SUBJECT: Forwards clarifications to NRC ATWS safety evaluation, per  
 900731 ltr re diverse auxiliary feedwater actuation sys -  
 conceptual design & implementation schedule for 10CFR50.62  
 ATWS rule.

Subject: Palo Verde Nuclear Generating Station (PVNGS)  
Units 1, 2 and 3  
PVNGS Response to NRC ATWS Safety Evaluation  
File: 90-056-026

APS CLARIFICATIONS

NRC ATWS SAFETY EVALUATION

DAFAS CHANNEL A SYSTEM DIAGRAM

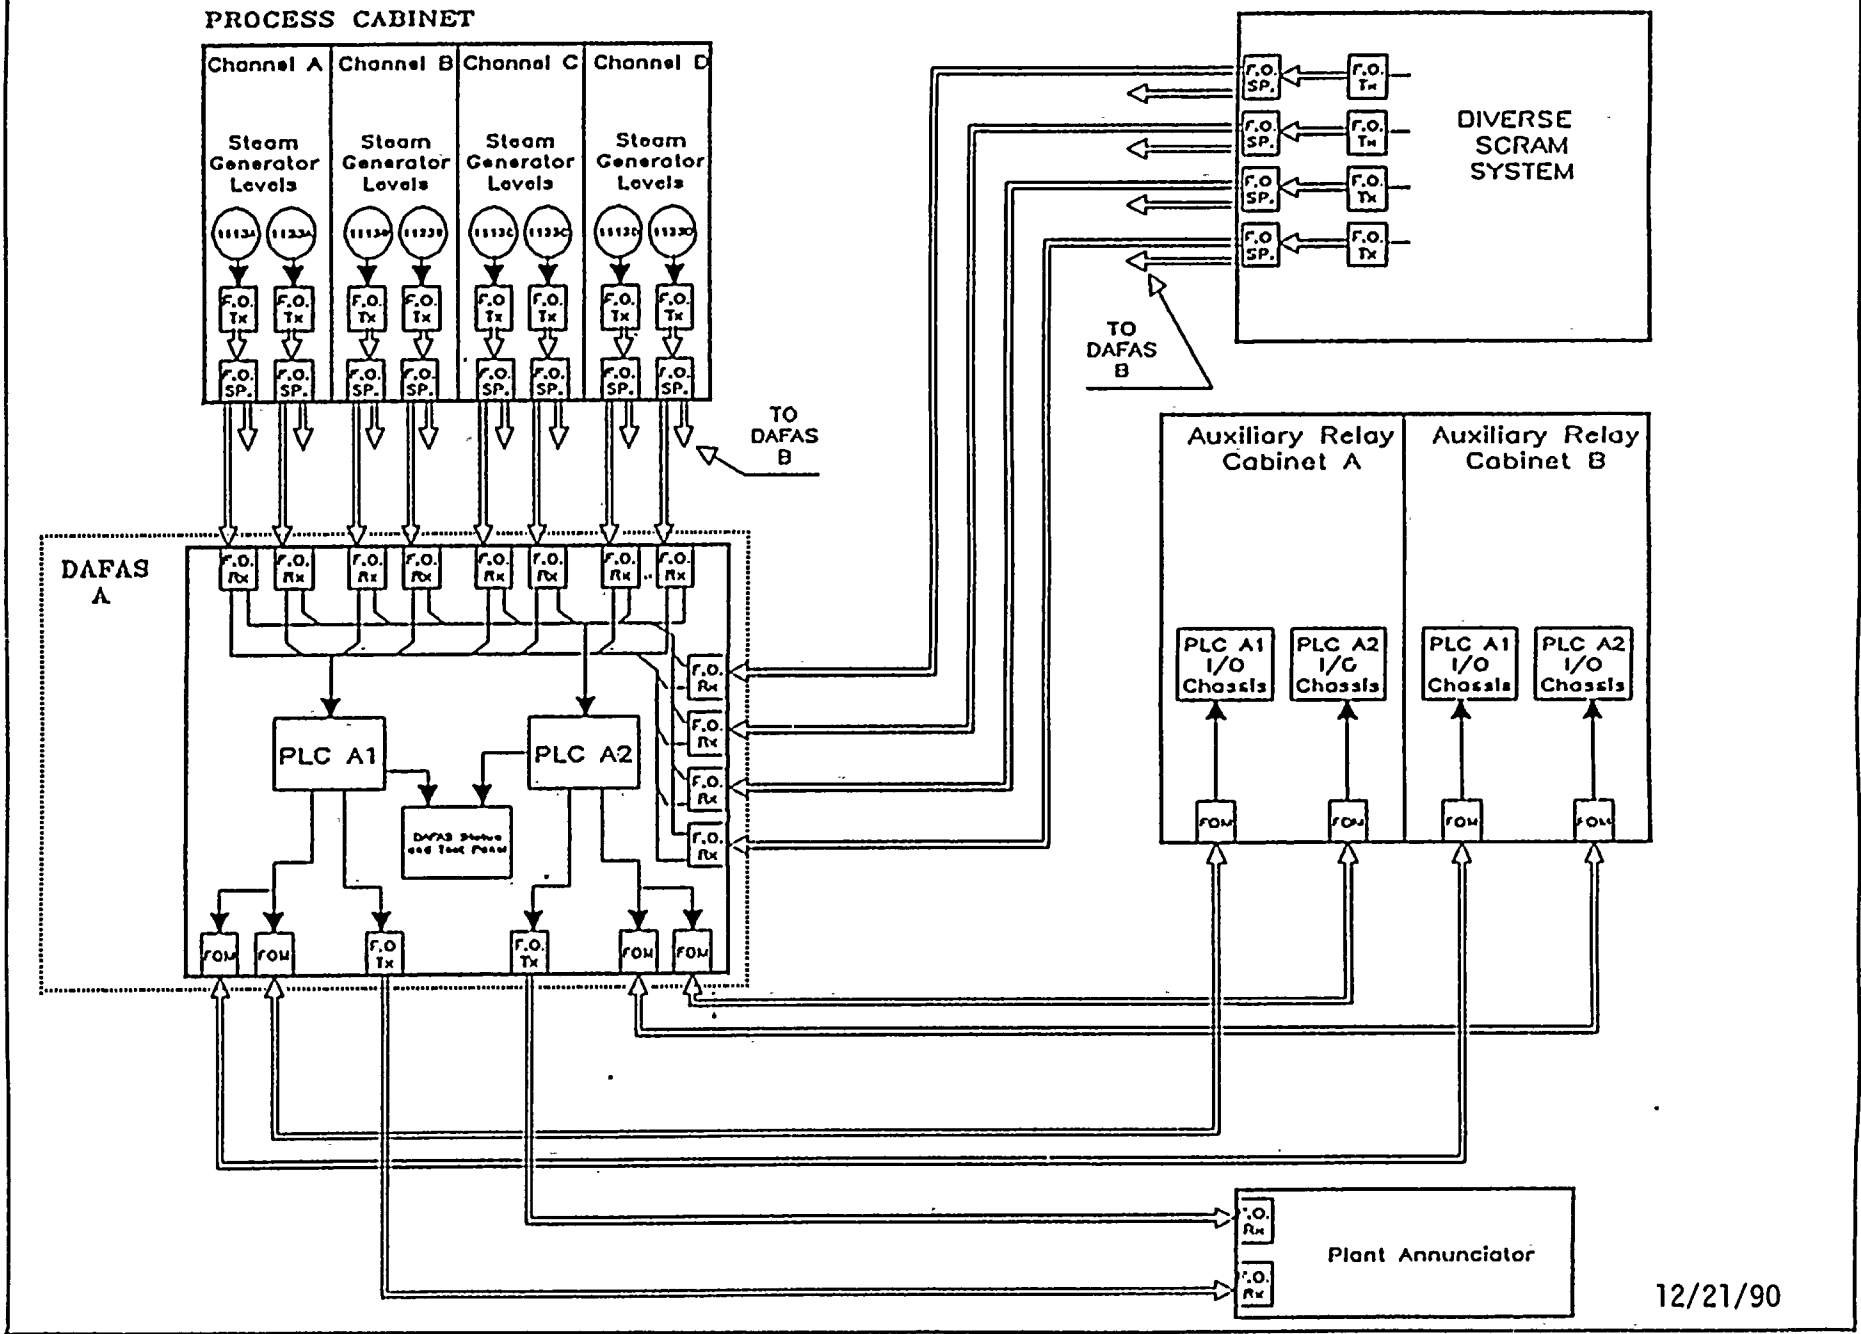
"DAFAS will be blocked by the Main Steam Isolation System (MSIS) and by the AFAS to prevent control and safety competing actions when AFW flow to a ruptured steam generator is terminated."

"The PVNGS 1,2,3 DAFAS design will use the existing safety related steam generator level instruments for the input signal and will send an actuation signal to the existing safety related AFW system. The DAFAS equipment will be diverse from that used in the Reactor Protection System (RPS) in that the DAFAS logic system will use a computer circuit board with solid state I/O modules while the RPS uses a bistable electro/mechanical system. The DAFAS energizes to actuate and the RPS de-energizes to actuate. The DAFAS interface with the AFW system will be through a relay which will not be used in the RPS. This relay will be of a different manufacturer than that of the AFAS solid state relays."

The purpose of the DAFAS block when an Auxiliary Feedwater Actuation Signal is present is to prevent the ATWS AOO system from interfering with the "smart" AFAS DBE rupture identification logic already present in the Palo Verde design.

The instrument sensor field bus power source for the DAFAS steam generator level transmitters is integrated with the sensor loop current to voltage converters. It is understood these were excluded from the diversity requirements, since they are technically part of the sensors, which are excluded from the diversity requirements of the ATWS Rule. The current to voltage converter/sensor field bus power source is considered the "sensor output," and is therefore also excluded from the diversity requirements of the ATWS Rule. The instrument channel components which process signals to the DAFAS and separately to the RPS from this point are separate and diverse.

Also, in the fourth sentence, "through a relay" should be through an initiation relay and in the fifth sentence "AFAS solid state relays" should be AFAS initiation relays.

DAFAS HARDWARE CONFIGURATION

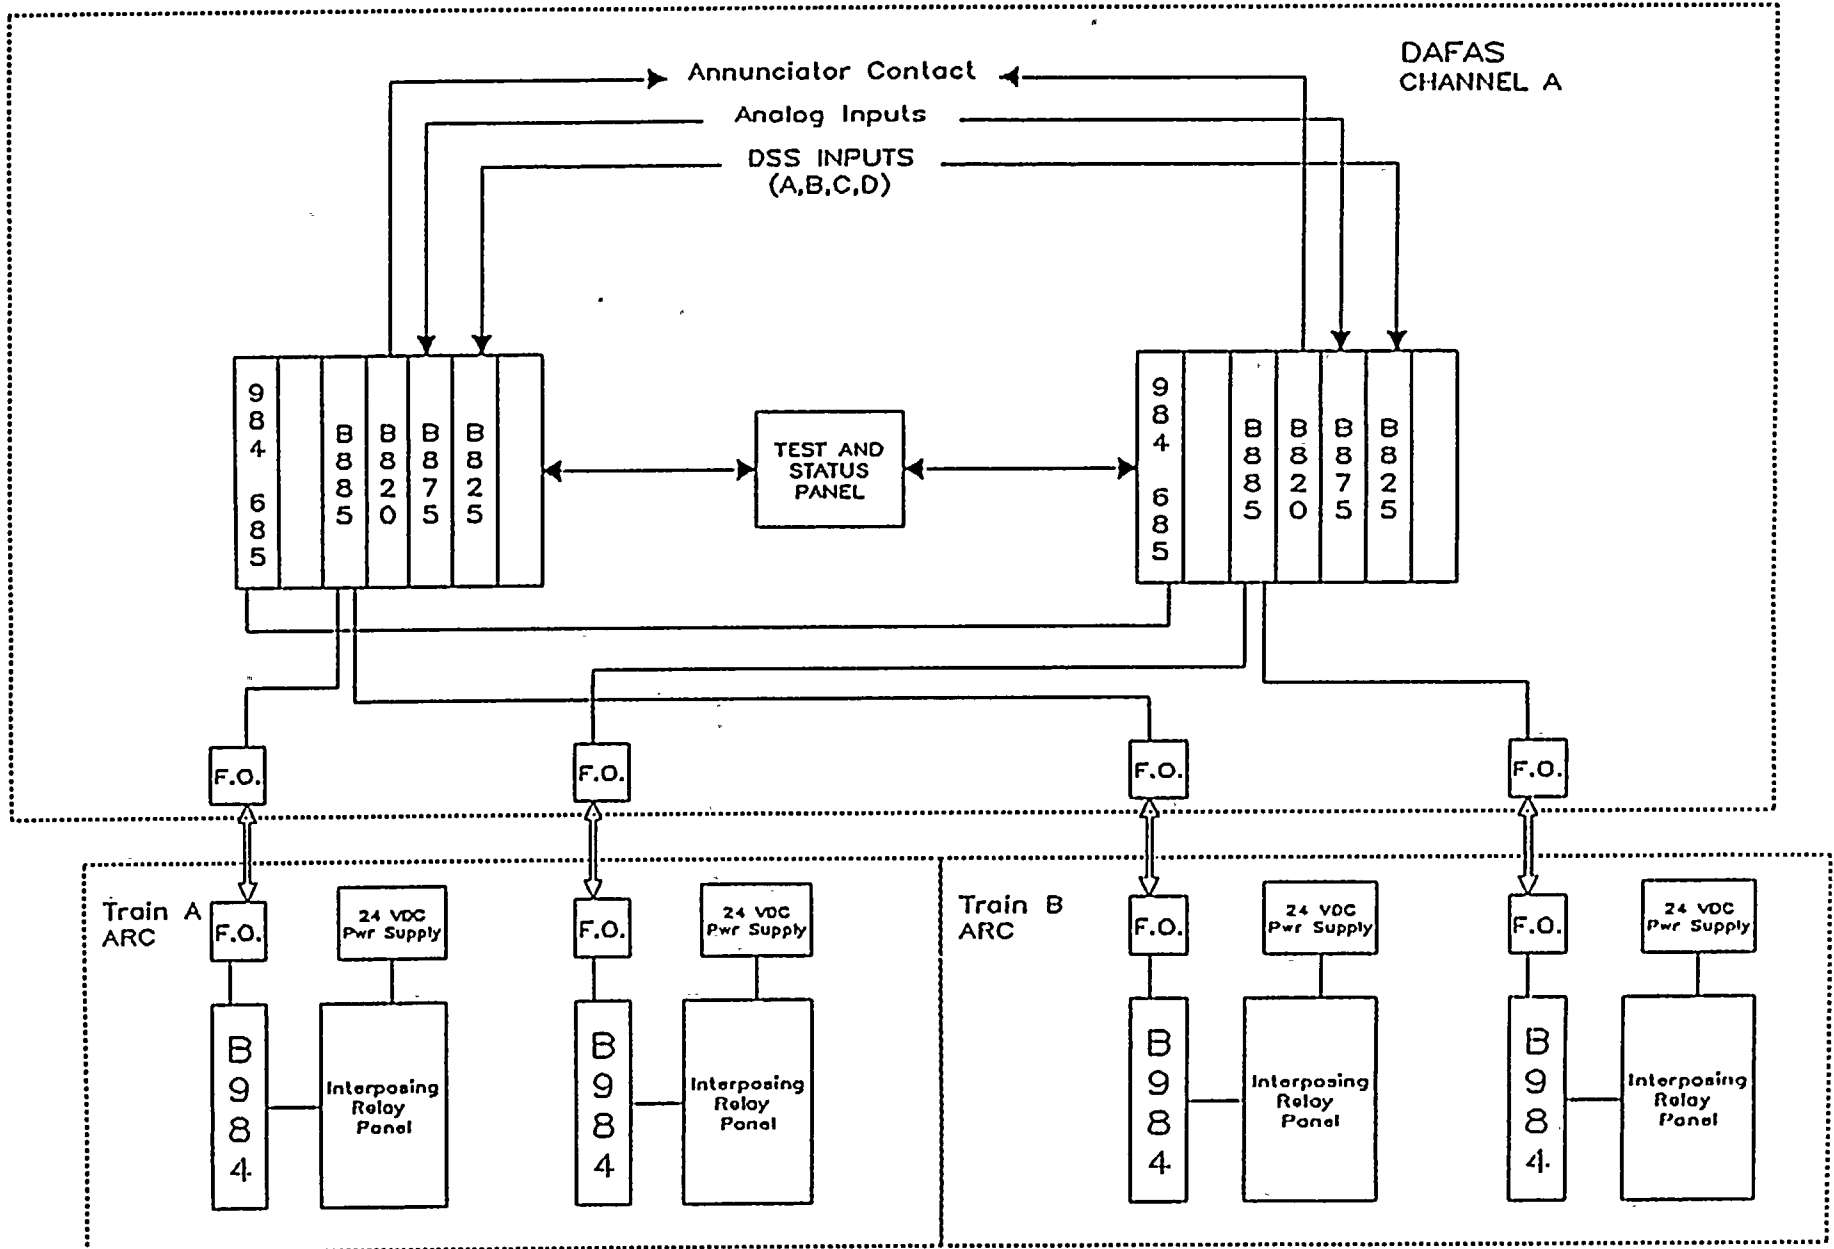
"Each channel of the DAFAS contains an uninterruptable power supply (UPS) which receives its power from 120 VAC vital buses. The UPSs can supply the DAFAS for up to an hour upon the loss of offsite power."

The DAFAS conceptual design submitted to the NRC by APS letter, dated July 31, 1990 (161-03369), included the use of UPS power sources. The final DAFAS design includes a power source to the DAFAS and power supplies within the DAFAS similar to those used in the Diverse Scram System (DSS). The Vital Instrument buses will provide power to the safety-related DAFAS cabinets. Power supplies from a different manufacturer than the existing RPS will be used in the DAFAS.
